Response to reviewer comments

This study compared three wind speed distributions of kernel, Weibull, and Rayleigh model to estimate vertical average wind power density by using meteorological tower data over varied desert steppe terrain. The topic is very interesting and has important implications for accurate and reliable wind energy evaluation. This study has the potential to provide new insights about three key parameters (c , k , and z_0) should be dynamically considered for estimating wind energy resources under varied desert steppe terrain contexts. The manuscript is written clearly and organized. While I found some minor issues need to be addressed. My recommendation is to accept with minor revision.

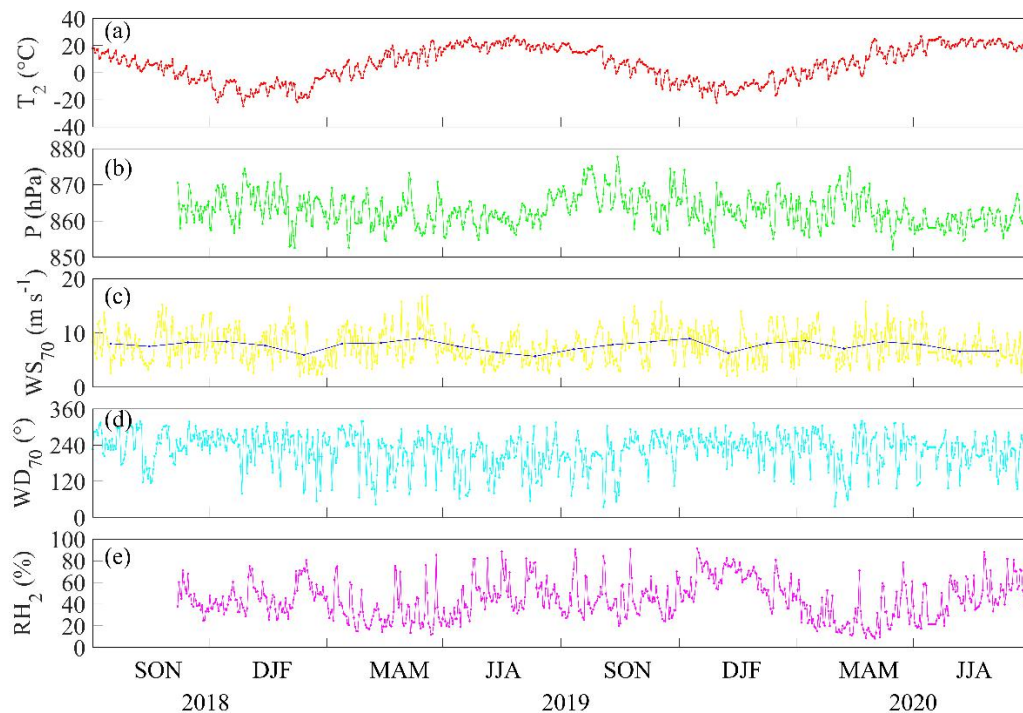
Lines 115, 117, ... and figure 2, what are the height for daily average temperature and relative humidity? please clarify them in the main text and figure captions.

Response: Many thanks for your question and kind suggestion. The height of the daily average temperature and relative humidity is 2 m. Amended.

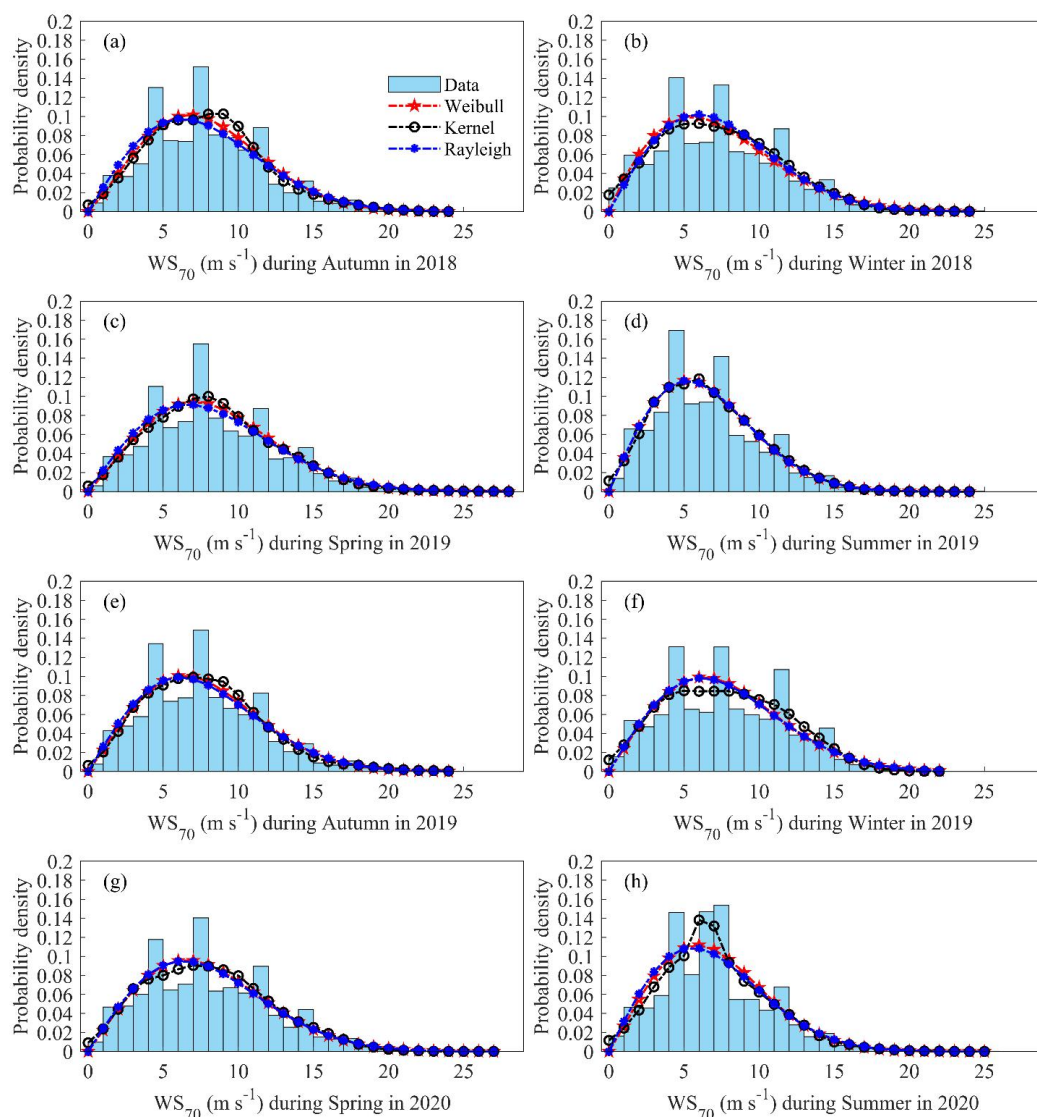
Please accordingly revise all the x-axis titles, for instance in figure 4a, it is should be that WS70 (ms-1) during Autumn in 2018.

Response: Many thanks for your kind suggestion. We have revised all the x-axis titles.

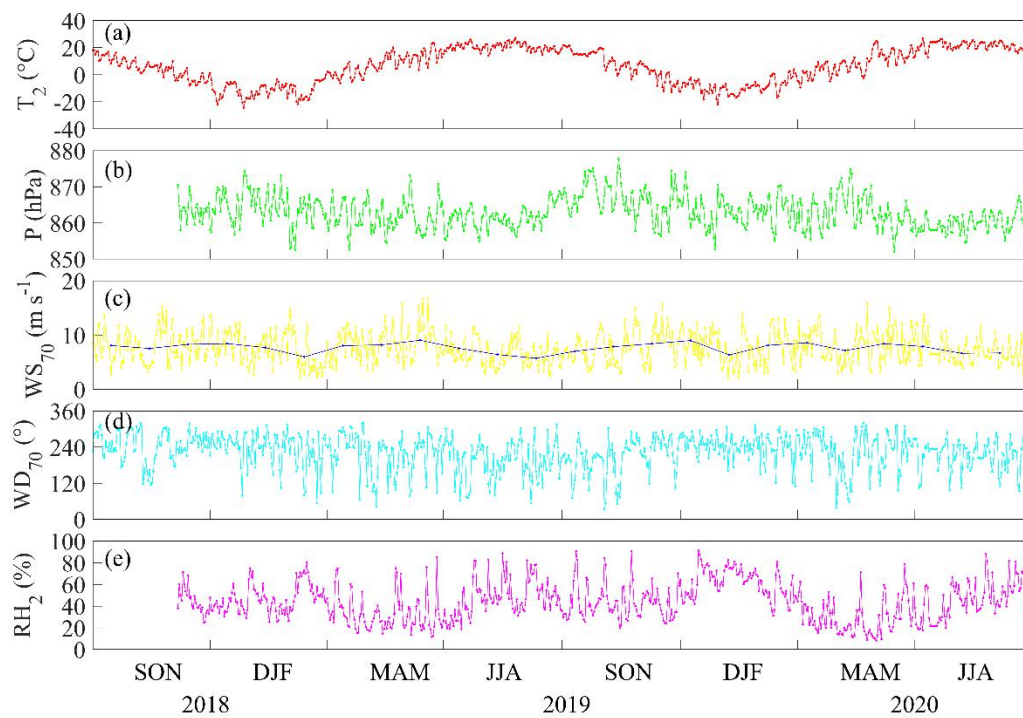
Figure 2c. A curve of monthly averaged wind speed added is more informative.

Response: Thank you very much for your kind suggestion, we have added a curve of

monthly averaged wind speed as following.

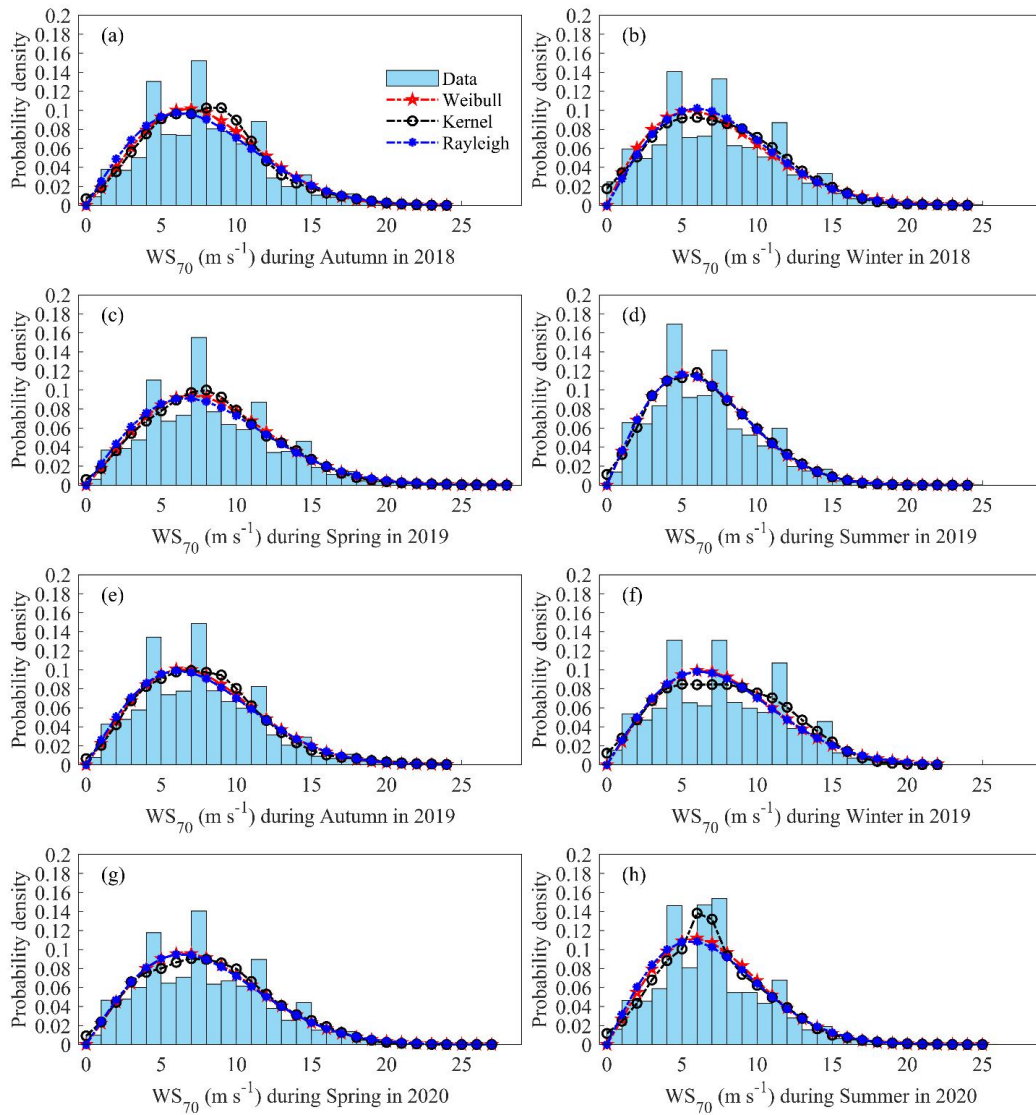
Figure 4. The x-label should be WS_{70} ($m s^{-1}$). Season and year information should be texted in each plot.

Response: Many thanks for your kind suggestion. Amended.

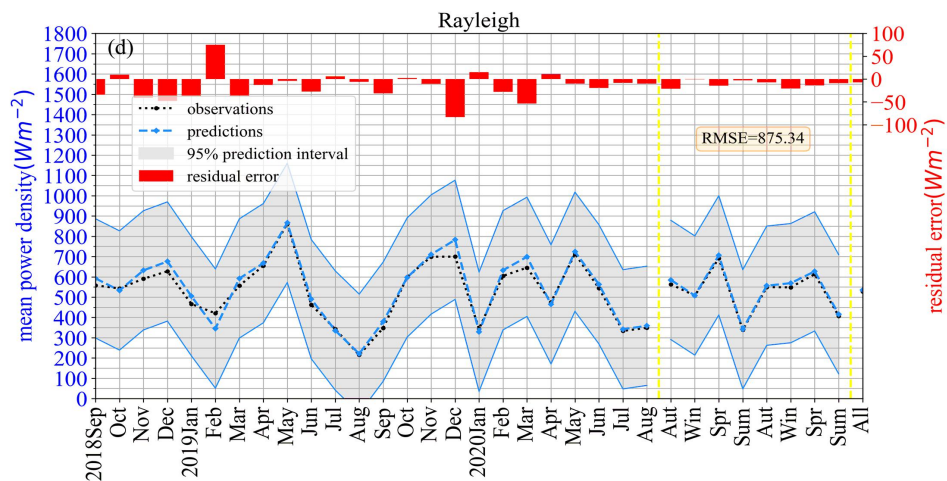
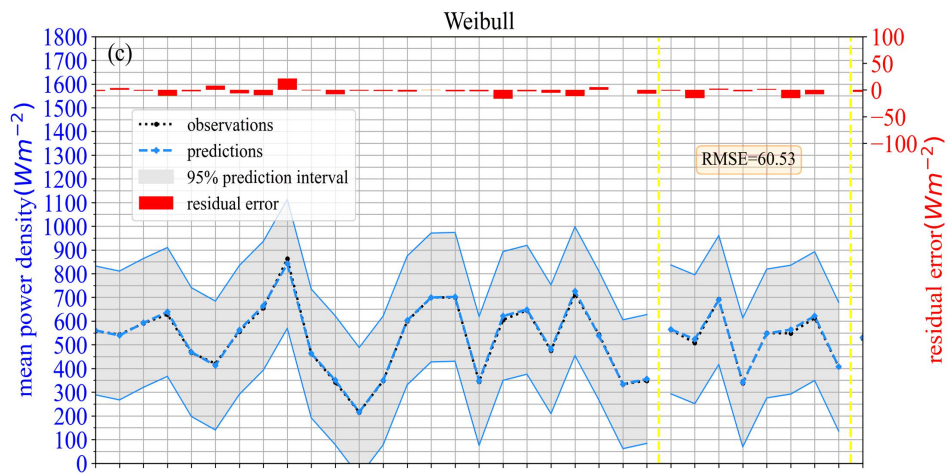
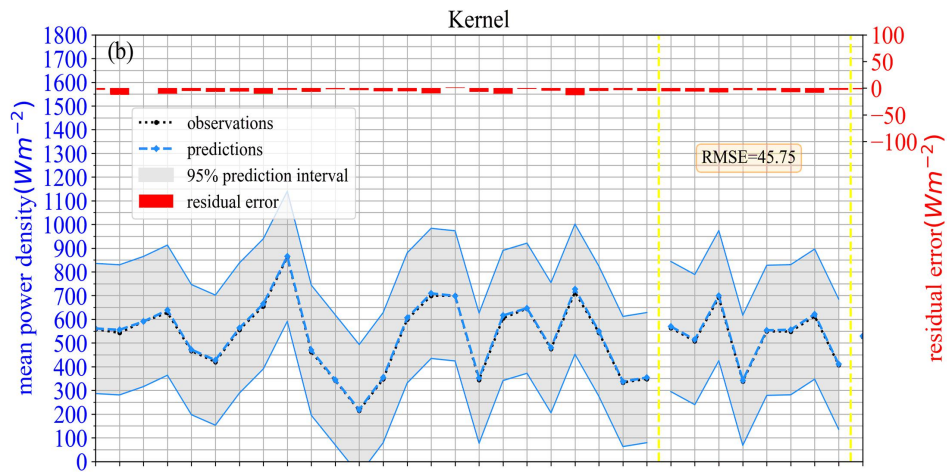
What is the unit of legend in figure 5?

It is unclear for right y x-axis title, confused.

Figure 5. No need to give x-axis tick-labels in every plot as all plots used one x-axis. The font size need to be unified for all the labels. The word “period” is not needed.

Response: Many thanks for your question. The unit of the legend is W/m². We have added legend unit in the caption of Figure 5.

Response: Many thanks for your question. The total average power density on the right y-axis in (a) is the average power density of the grid-connected wind turbine with a radius of 41.5m represented by the red dots in Figure 1c. We have added annotation of right y x-axis title to the caption of Figure 5.

Response: Thanks for your suggestions. Amended.

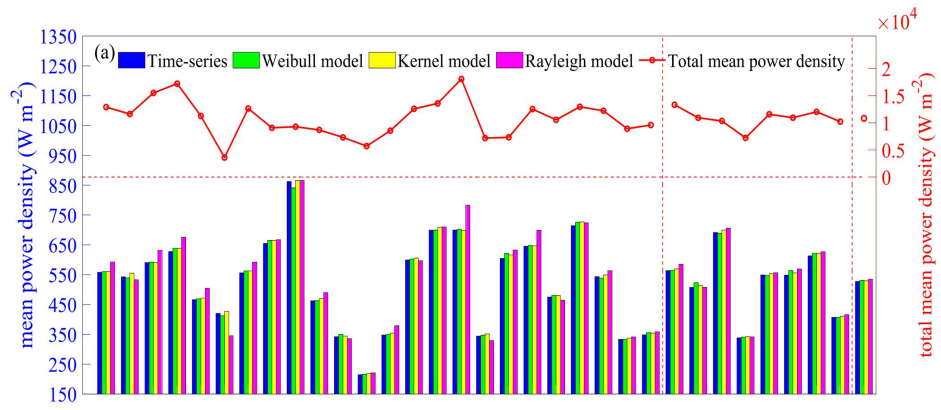
Figure 6. The x-label is not “Altitude”, it should be Height (above the ground level). What is the unit for x-label? The x-tick label should be 10, 20, 30, 40, ... , 100.

Response: Thanks for your suggestion. Amended.
